Washington State Transportation Commission

The Interstate Bridge Replacement Program's "Tunnel Concept Assessment" must be retracted. It is based on extremely incorrect estimates of excavation and dredging,

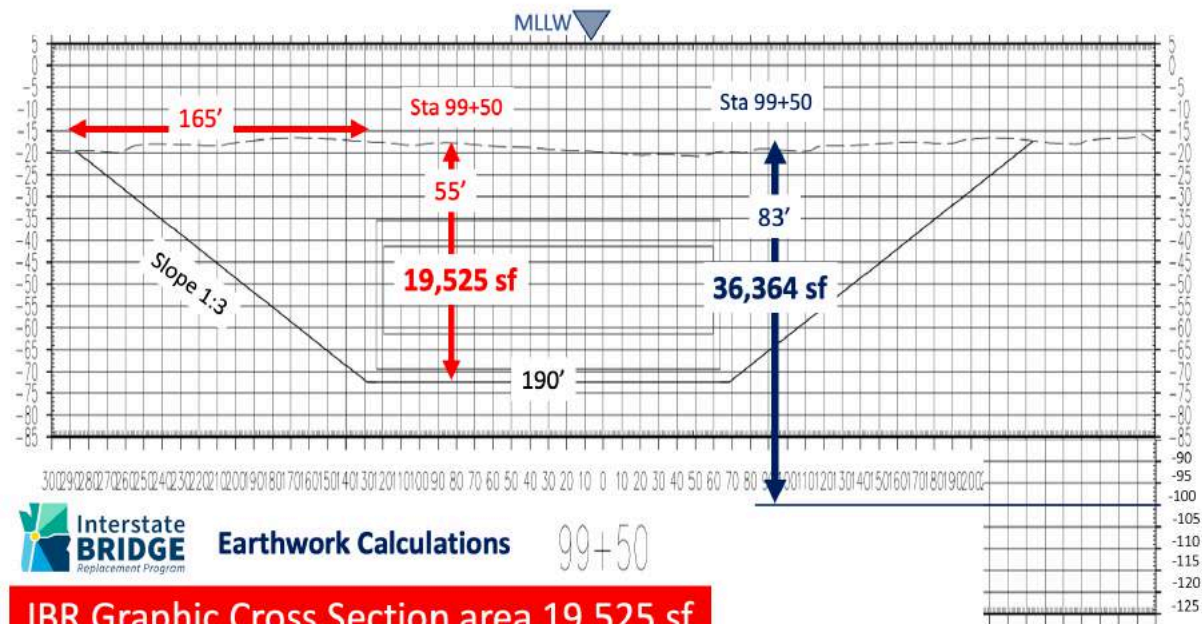
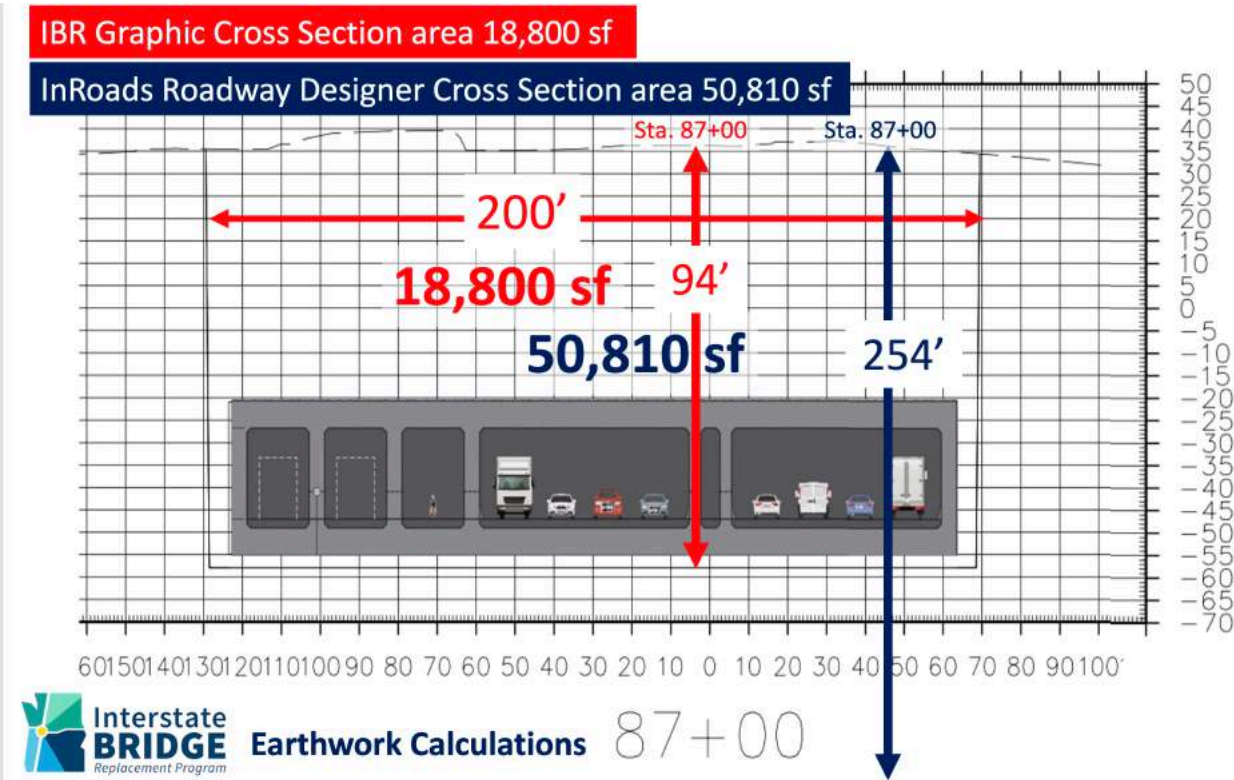
However, upon reviewing what you provided, it appears your representative diagram and excavation calculations at 87+00 do not account the construction need for laying back slopes during excavation (and the resulting surface property impacts), or the alternative to have temporary structural walls which come with an extremely high cost. As you know, one of these options must be accounted for to prevent the sides of the trench from caving in during construction of an ITT.

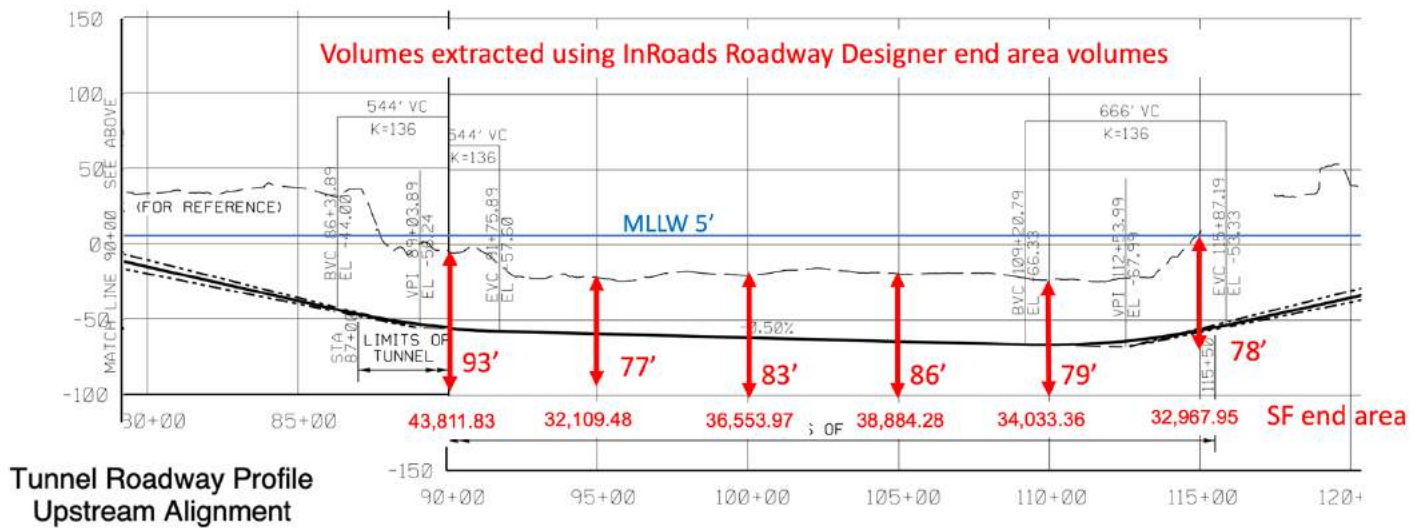
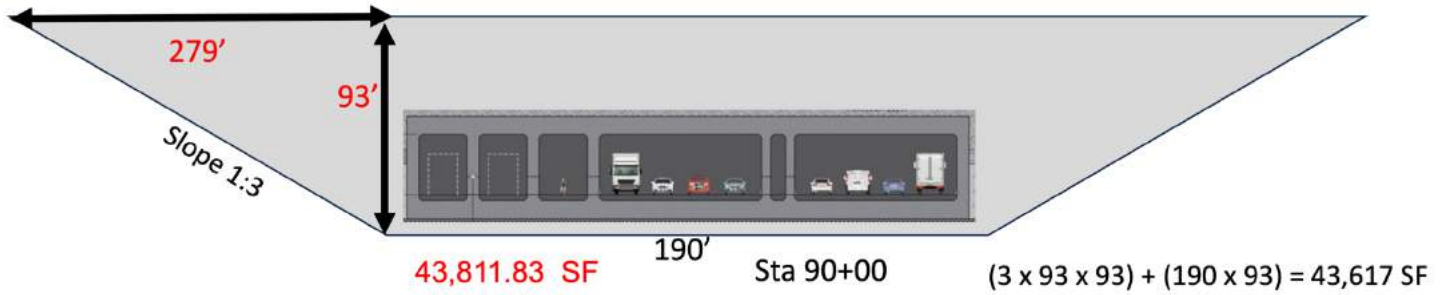
Every Cross Section SF must equal InRoads SF, IBR's are wildly different.

IBR Graphic Cross Section area 19,525 sf

InRoads Roadway Designer Cross Section area 36,364 sf

The end areas SF used by the InRoads Roadway Designer require depths 30' to 40' deeper than IBR's Tunnel Roadway Profile.

Table 1. Preliminary Tunnel Excavation Quantities

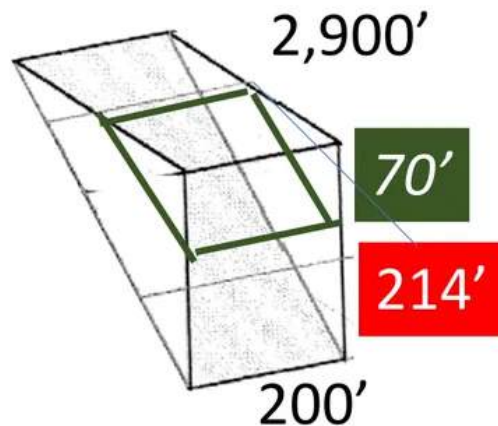
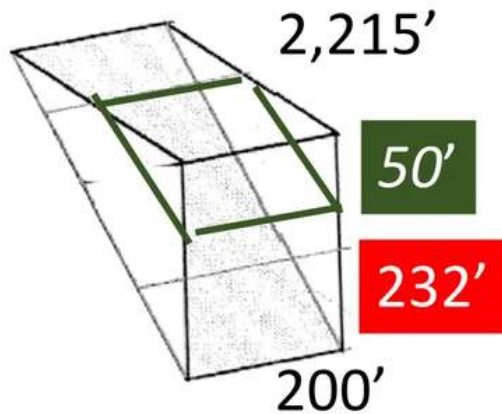
Ridiculous and misleading quantities that require 200' excavations & dredge depths of 80'. Realistic quantities are 1/4 as large and costly.

Misleading
